Interfab Shirt Manufacturing Ltd. (Unit-2) Stoffatex Fashion Ltd.

580/1, Uttar Shalna, ward 23, Ipsha, Gazipur
(24.047712, 90.379556)
28th July & 9th August 2019

Observations

Discrepancies between structural drawings and on-site observations

Observations: Childcare and Healthcare Building

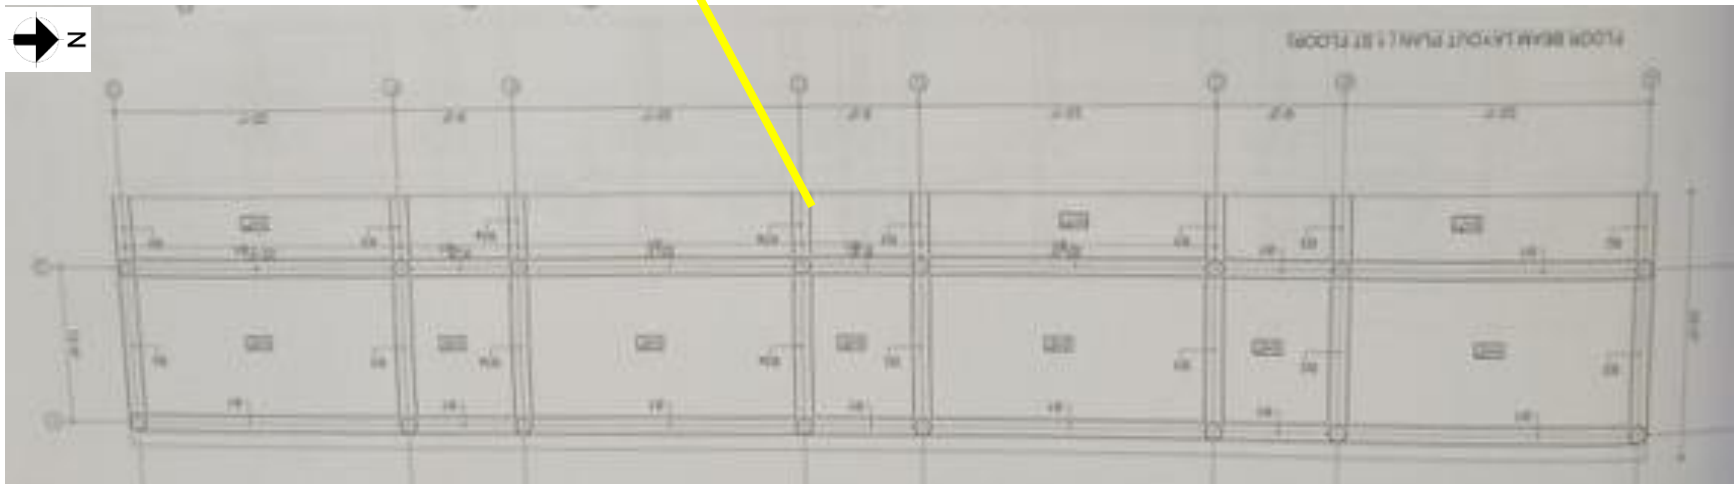
Number of rebar does not match with column schedule. 9 number of exposed rebars were found instead of 12 at roof level. Also, cantilever beam was shown in beam layout plan which was not found on site.

Possible vertical extension

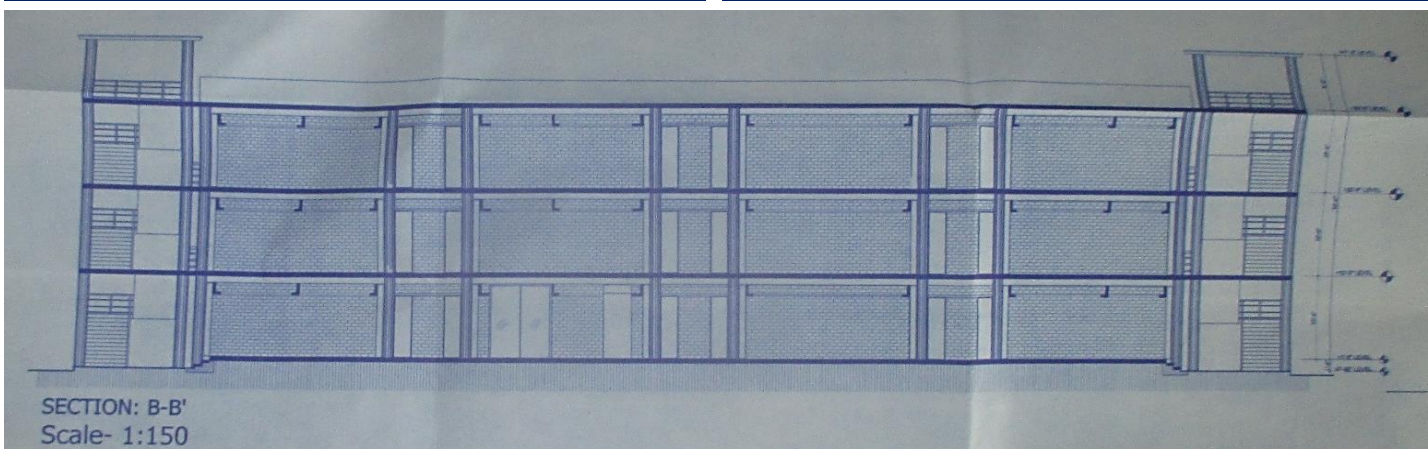
This building is permitted for three (G+2) storied from local authority. Currently, the building is one storied. Factory owner has plan to extend the building vertically up to three storey. Extended portion of column rebar was found at roof level which indicates the possibility of vertical extension. The factory engineer is required to carried out a Detail Engineering Assessment considering BNBC provision prior to any extension work.

Item No.	Observation	Recommended Action Plan	Recommended Timeline
1	Discrepancies between Structural drawings and on-site observations	The factory engineer is required to survey the structure and produce as-built drawings with complete structural information.	6-weeks
2	Possible vertical extension	The factory engineer is required to carry out a Detail Engineering Assessment considering BNBC provision prior to any extension work.	6-weeks
3	Possible vertical extension	Follow the recommendations of Detail Engineering Assessment report.	6-months
4	Discrepancies between drawings and on-site condition	The factory engineer is required to survey the structure and produce as-built drawings with complete structural information.	6-weeks
5	Possible vertical extension	The factory engineer is required to carry out a Detail Engineering Assessment considering BNBC provision prior to any extension work.	6-weeks

Discrepancies between drawings and on-site condition

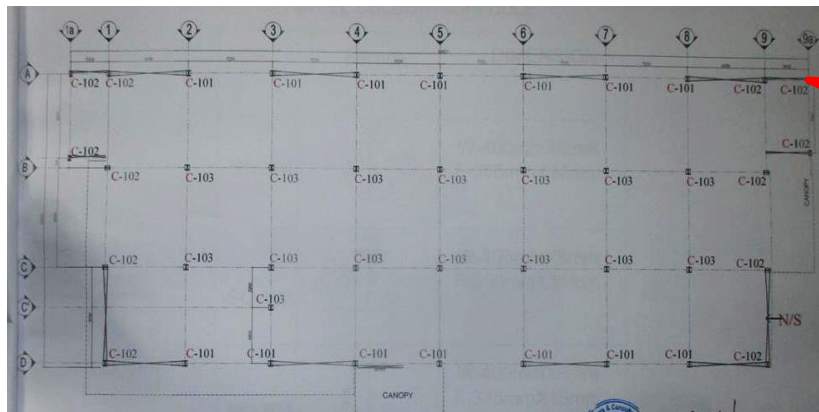
Flange thickness of stair column did not match with the provided drawings. Also, bracing at ground floor stair was not being installed as per bracing layout. The factory engineer is required to produce an “as constructed” drawings with complete structural information.

13 mm thickness
of column flange
instead of 14 mm

No Bracing at GF level

Possible vertical extension

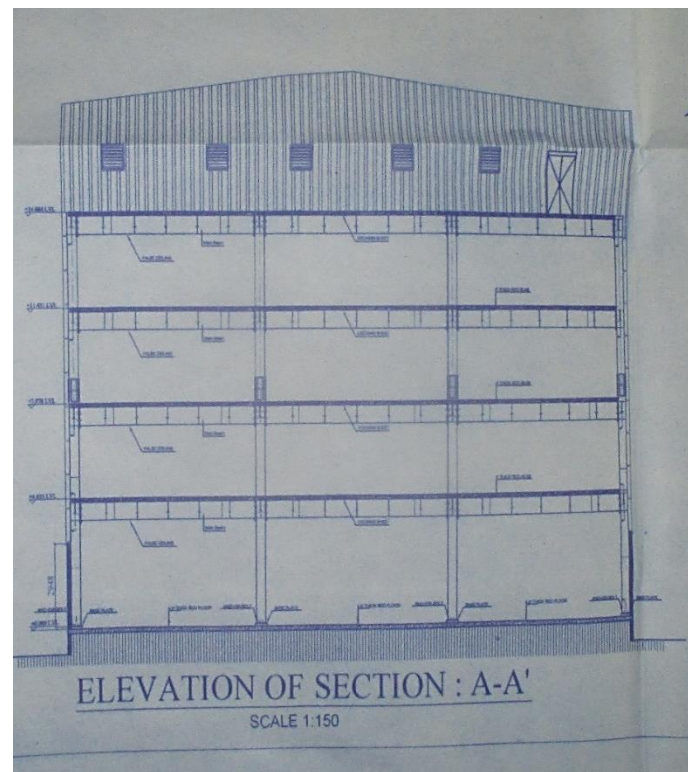
This building is permitted for five (G+4) storied from local authority. Currently, the building is two storied. The factory owner has plan to extend the building vertically up to five storey. Extended portion of steel column was found at roof level which indicates the possibility of vertical extension. The factory engineer is required to carry out a Detail Engineering Assessment considering BNBC provision prior to any extension work.
